T.I. no.: 2022-10 Updated: -	Topic: 2nd Temporary Change of Grinding Disks
--	--

Date: 31.03.2022	Priority	Need for action
Affected machines: SC Club	High	As soon as possible
From serial number: 61608	X Medium	X On next visit to the machine
As of date: immediately	Low	FYI only

IN-HOUSE MANUFACTURED GRINDING DISKS

Factory setting in-house manufactured grinding disks

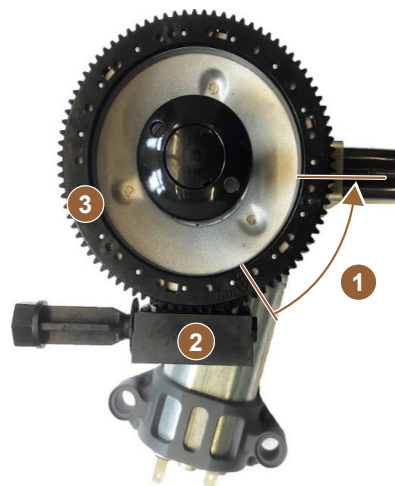
The in-house manufactured grinding discs would change the following characteristics with the same factory setting - compared to the standard Italmill grinding disc:

- approx. 100 µm finer grinding result
- approx. 1 A higher current consumption

In order to get an unchanged grinding result and the same beverage quality, the factory setting of the grinders was therefore set coarser by 1 grinding degree, with the following result:

- Same grinding result as standard Italmill grinders
- Same current consumption as standard Italmill grinders
- approx. 15% higher charge capacity

Espresso grinder

Open upper grinding disk (3) from marked block position 13.5 teeth (2).

Café Crème-Mühle

Open upper grinding disk (3) from marked block position 19.5 teeth (2).
